South Texas Project Electric Generating Station P.O. Box 289 Wadsworth, Texas 77483

U7-C-STP-NRC-090074

South Texas Project  
Units 3 and 4  
Docket Nos. 52-012 and 52-013  
Response to Request for Additional Information

Attached are responses to NRC staff questions included in Request for Additional Information (RAI) letter numbers 76 and 89 related to Combined License Application (COLA) Part 2, Tier 2, Section 6.2 and Appendix 3B.

**Figure 6.2-6 Pressure Response of Primary Containment for Feedwater Line Break**

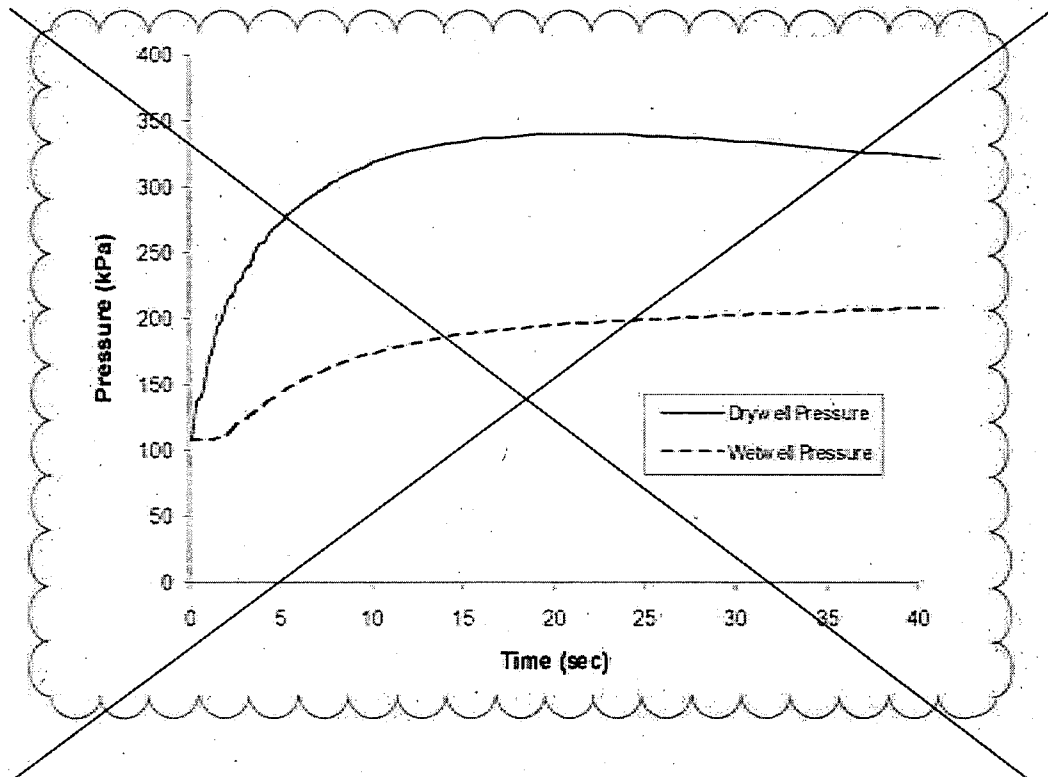
*The short term pressure peak (268.7 kPaG) of Figure 6.2-6 is the peak pressure for the whole transient. Figure 6.2-8 shows temperature time histories for the suppression pool, wetwell, and drywell temperatures. The peak pool temperature (96.9 99.5°C) is reached at 15,350 6600 seconds (4.264 1.833 hours). This is less than the suppression pool temperature value of 100°C which is used in the net positive suction head available (NPSHA) calculations.*

Figure 1 – FWLB Break Flow Rate (Feedwater Side)

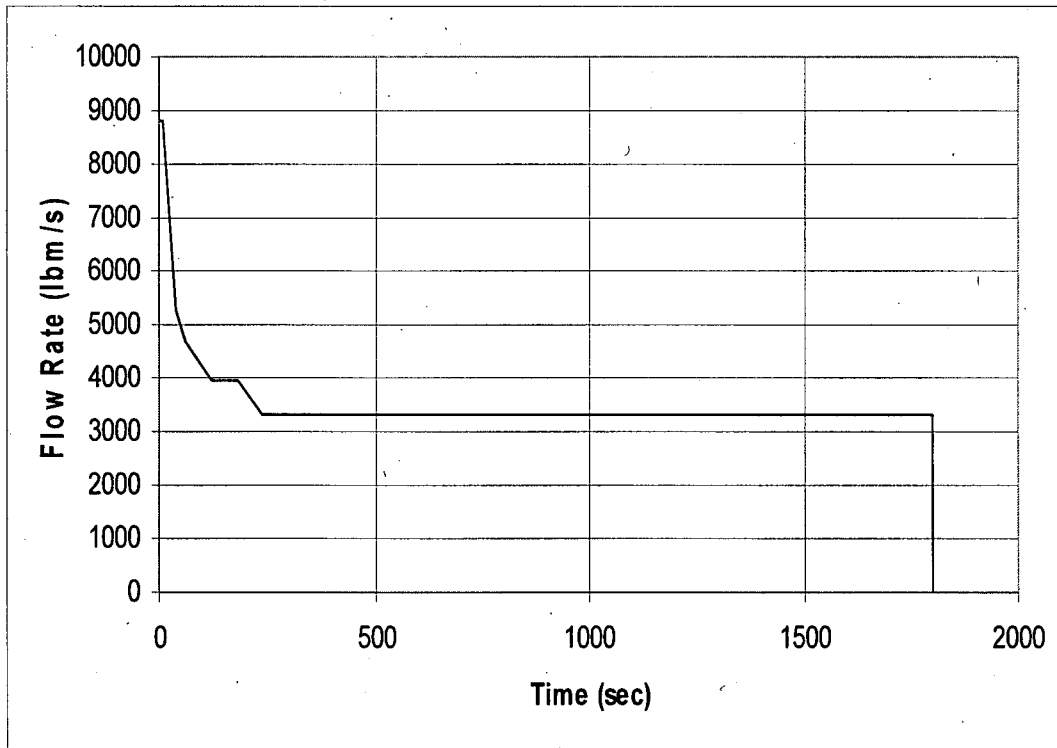
- ADS valves opening sequence after receiving the ADS initiation signal,
- a figure showing the feedwater line break flow from the feedwater system side of break (i.e., Figure 6.2-3 in STP COLA, Rev. 2 with the time axis varying from 0.0 to 5 hrs),

- Figure 1 shows the feedwater line break flow from the feedwater system side of the break. As shown in the figure, the feedwater flow terminates at 30 minutes, thus the flow from 30 minutes to the requested 5 hour time is zero.

Figure 2 FWLB Enthalpy (Feedwater Side)

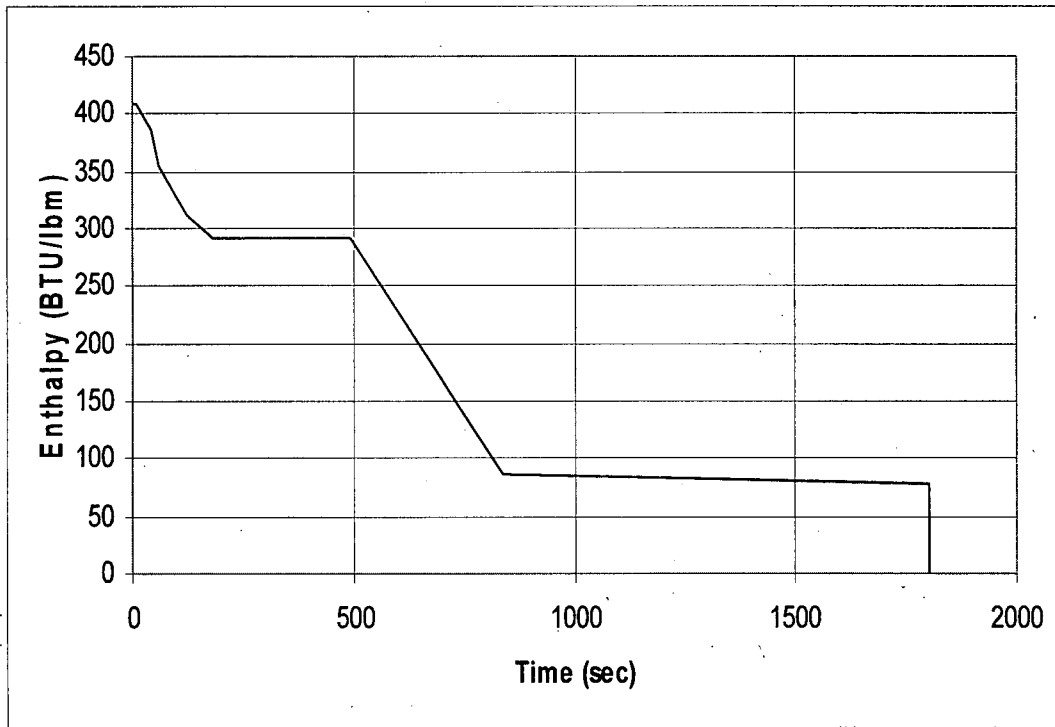
- a figure showing the feedwater line break flow enthalpy from the feedwater system side of break (i.e., Figure 6.2-4 in STP COLA, Rev. 2 with time axis varying from 0.0 to 5 hrs),

- Figure 2 shows the feedwater line break flow enthalpy from the feedwater system side of the break. As shown in Figure 1, the feedwater flow terminates at 30 minutes, thus the flow enthalpy from 30 minutes to the requested 5 hour time is zero.

Figure 3a – FWLB Short Term Break Flow Rate (RPV Side)

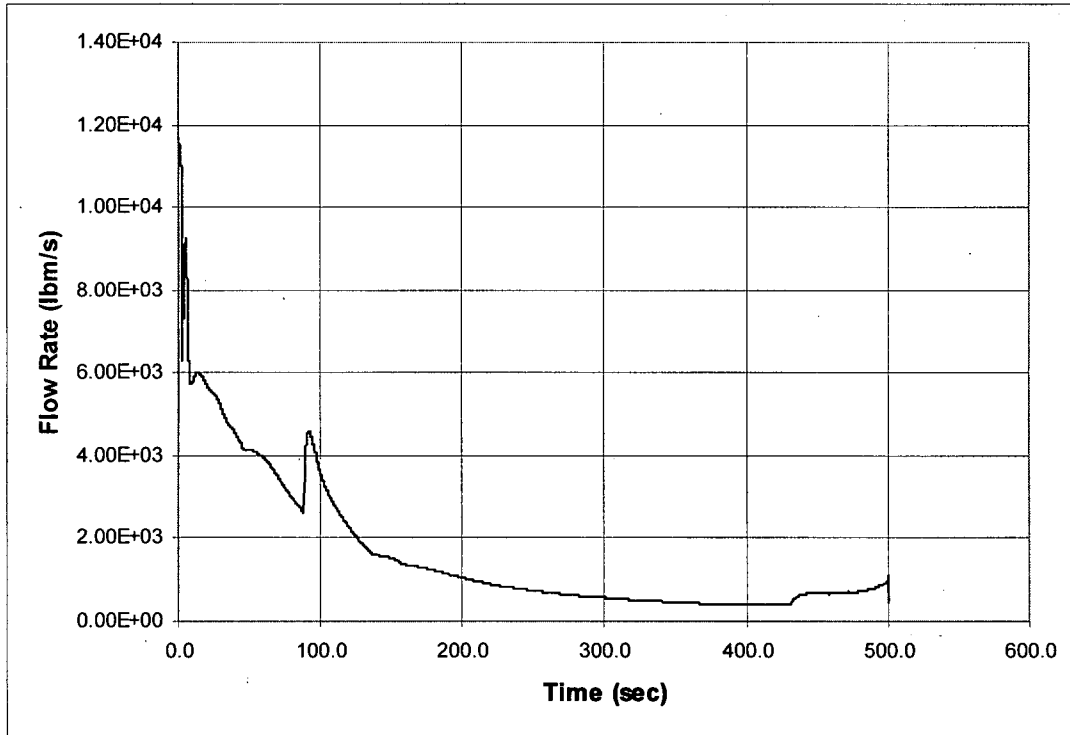
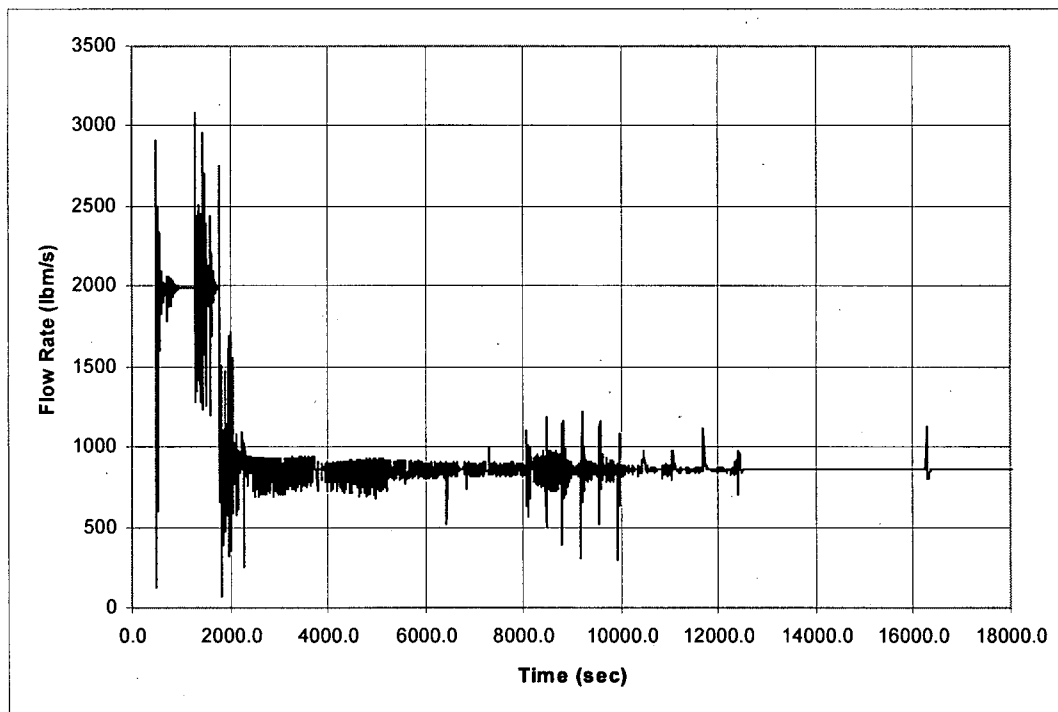
- a figure showing the feedwater line break flow from the RPV side of break (i.e., Figure 6.2-23 in ABWR DCD with time axis varying from 0.0 to 5 hrs),

- Figure 3a shows the short-term feedwater line break flow from the RPV side of the break from 0 to 500 seconds.
- Figure 3b shows the long-term feedwater line break flow from the RPV side of the break from 500 seconds to 5 hours.

Figure 4a – FWLB Short Term Enthalpy (RPV Side)

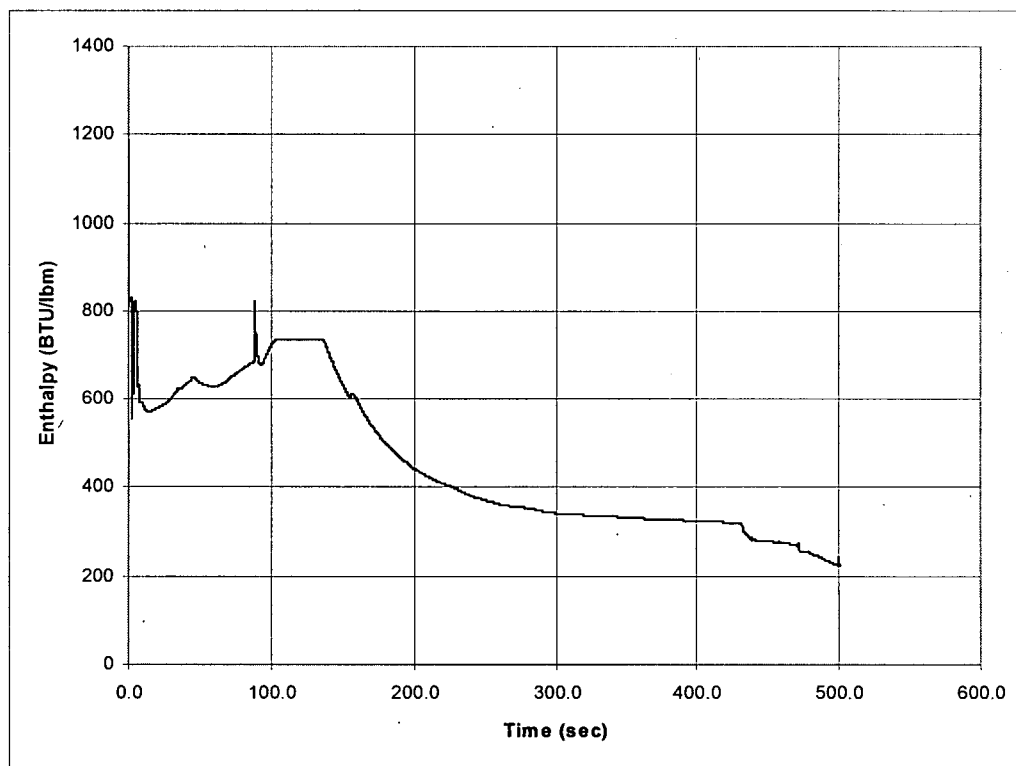
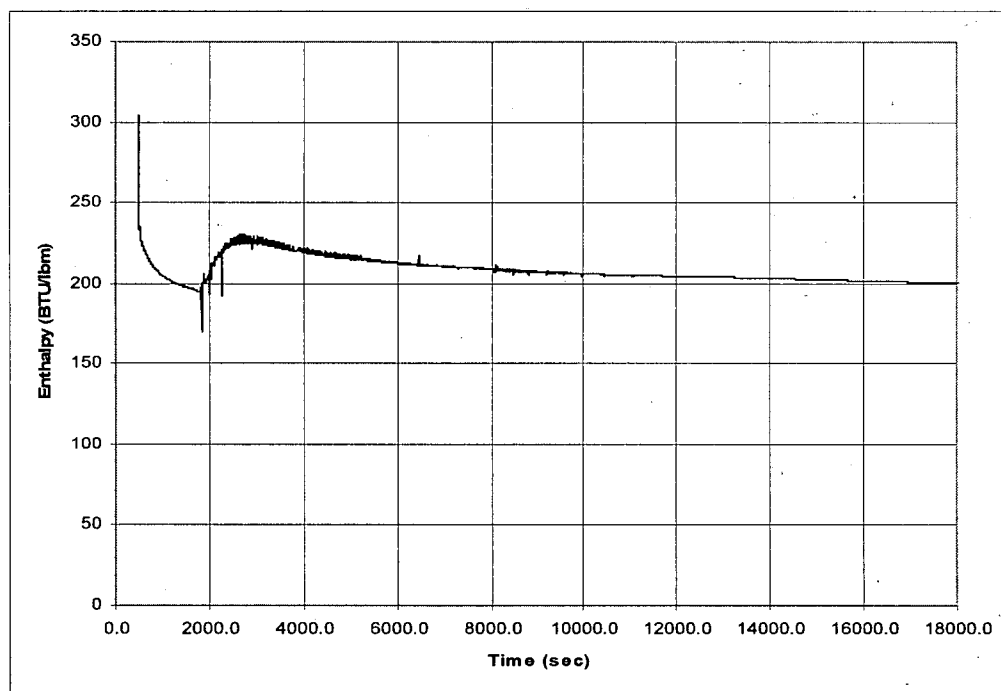
- a figure showing the feedwater line break flow enthalpy from the RPV side of break (i.e., Figure 6.2-23 in ABWR DCD with time axis varying from 0.0 to 5 hrs),

- Figure 4a shows the short-term feedwater line break flow enthalpy from the RPV side of the break from 0 to 500 seconds.
- Figure 4b shows the long-term feedwater line break flow enthalpy from the RPV side of the break from 500 seconds to 5 hours.

Figure 5a – MSLB Short Term Break Flow Rate (RPV side)

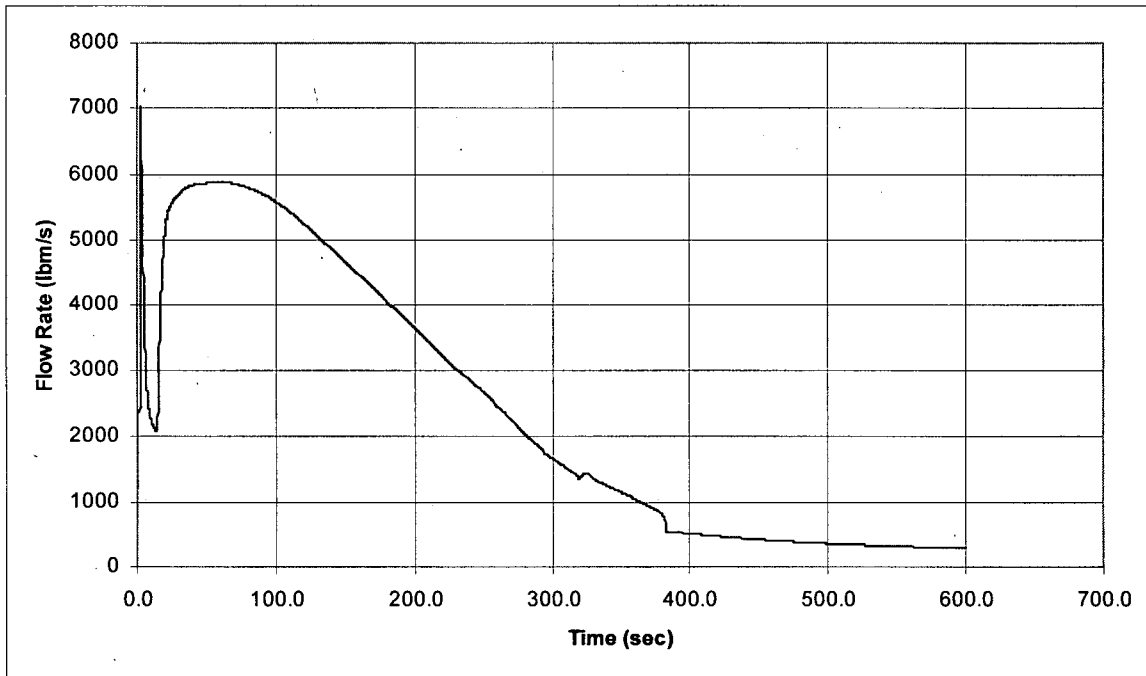
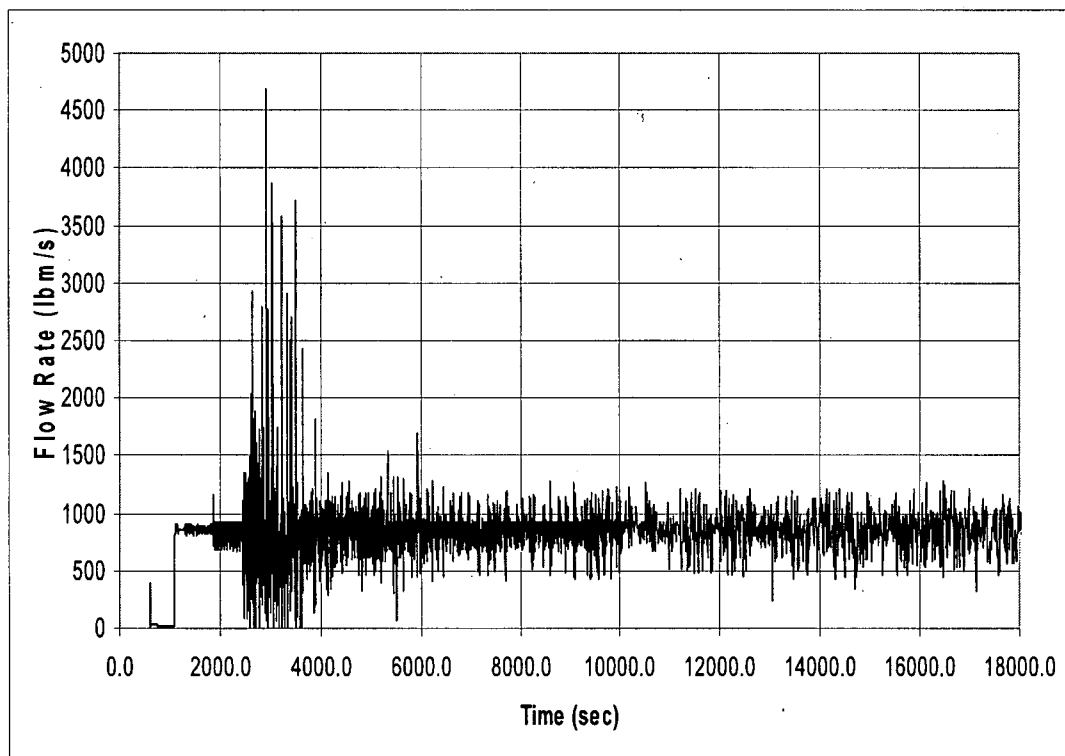
- a figure showing the main steam line break flow from the RPV side of break (i.e., Figure 6.2-24 in ABWR DCD with time axis varying from 0.0 to 5 hrs),

- Figure 5a shows the short-term main steam line break flow from the RPV side of the break from 0 to 600 seconds.
- Figure 5b shows the long-term main steam line break flow from the RPV side of the break from 600 seconds to 5 hours.

Figure 6a – MSLB Short Term Enthalpy (RPV side)

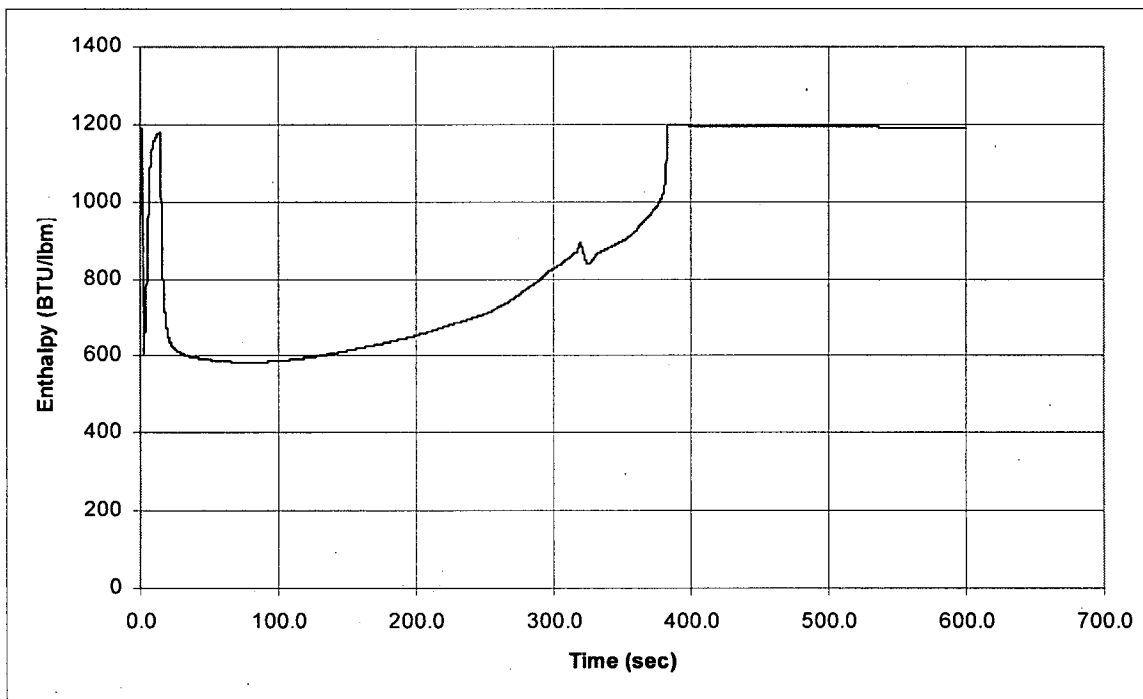
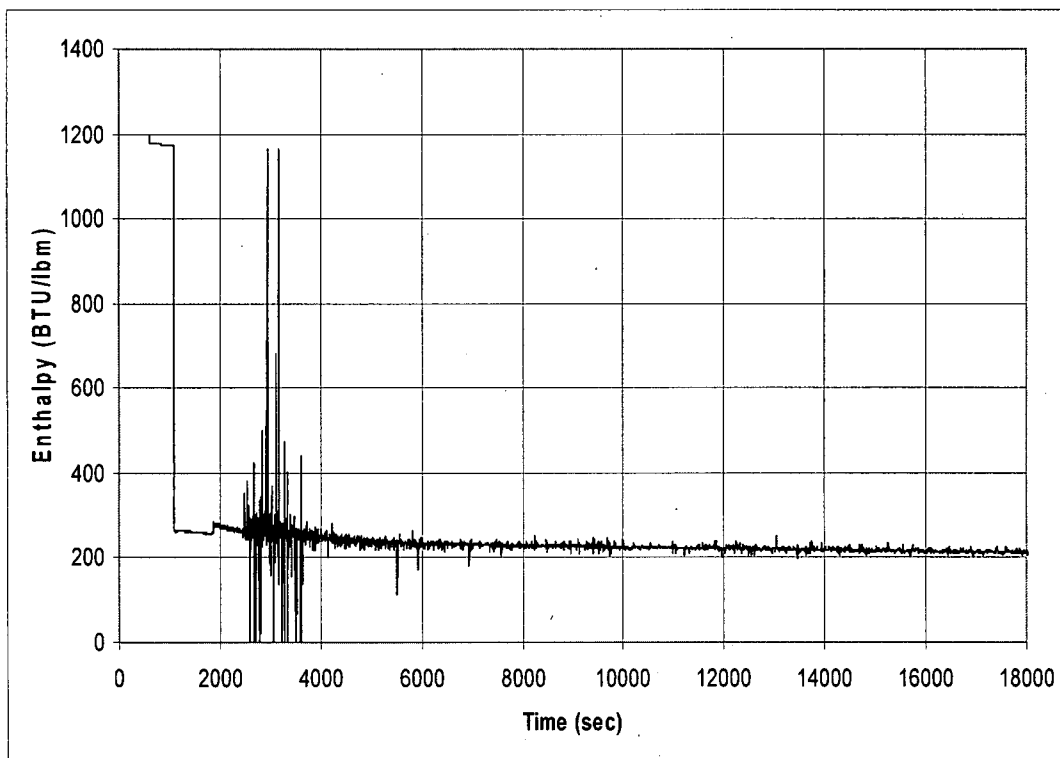
- a figure showing the main steam line break flow enthalpy from the RPV side of break (i.e., Figure 6.2-24 in ABWR DCD with time axis varying from 0.0 to 5 hrs),

- Figure 6a shows the short-term main steam line break flow enthalpy from the RPV side from 0 to 600 seconds.
- Figure 6b shows the long-term main steam line break flow enthalpy from the RPV side from 600 seconds to 5 hours.

Figure 7 MSLB Break Flow Rate (Piping Side)

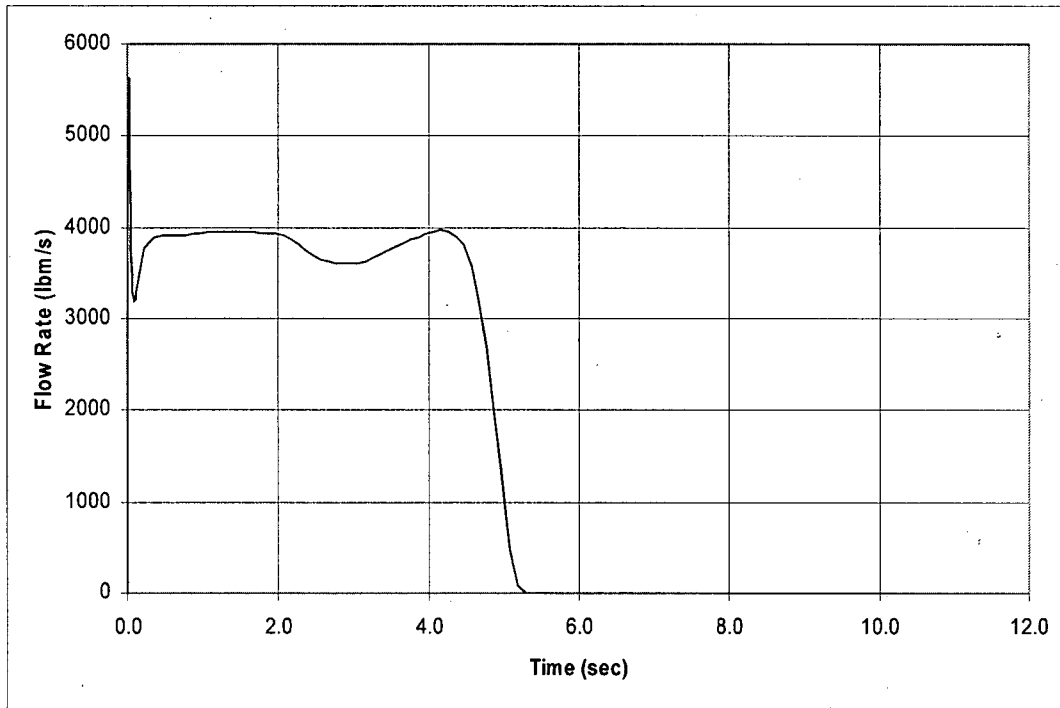
- a figure showing the main steam line break flow from the piping side of break (0 to 5 hrs),
- a figure showing the main steam line break flow enthalpy from the piping side of break (0 to 5 hrs),

- Figure 7 shows the main steam line break flow from the piping side of the break from 0 to 5.6 sec, at which time the flow is zero.
- Figure 8 shows the main steam line break flow enthalpy from the piping side of the break from 0 to 10 sec, at which time the flow is zero.

Figure 9 MSLB Feedwater Flow Rate and Enthalpy

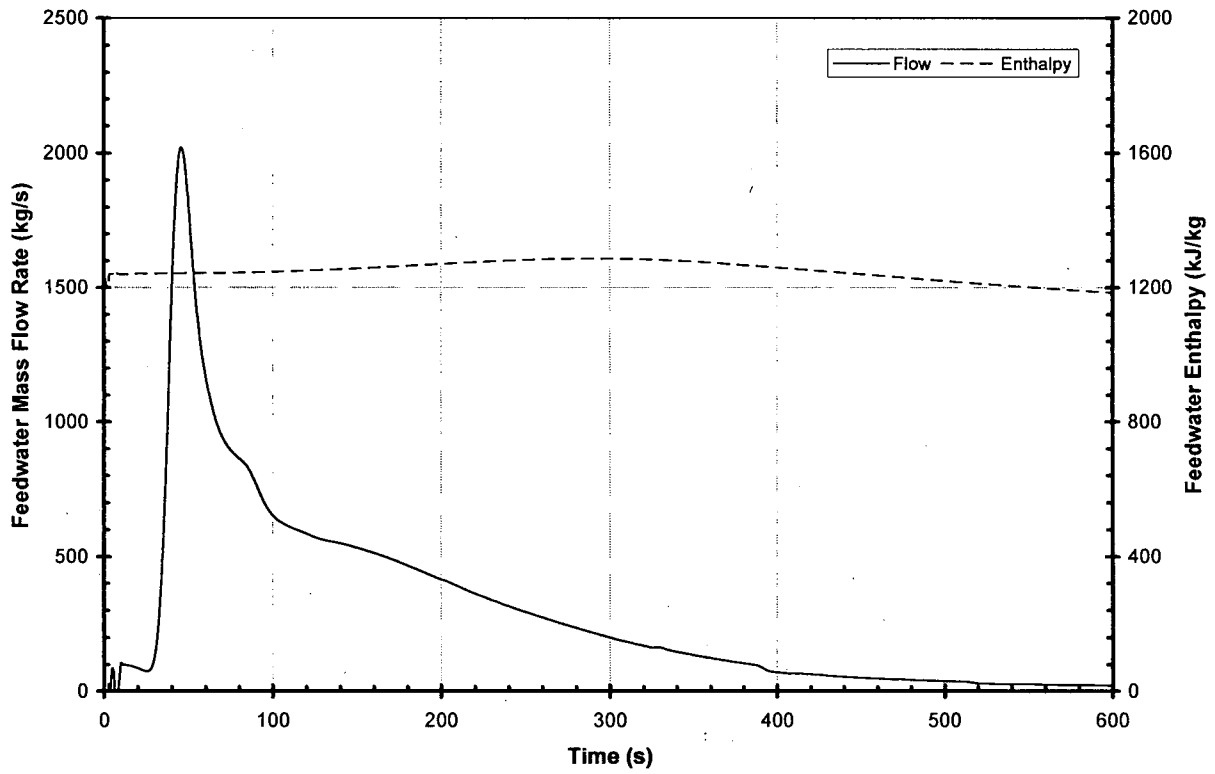
- a figure showing the feedwater flow rate and enthalpy assumed for the MSLB accident analysis as described in section 6.2.1 of STP COLA, Rev. 2.

- Figure 9 is the feedwater line flow and enthalpy from 0 to 600 sec assumed for the MSLB accident from 0 to 600 sec.
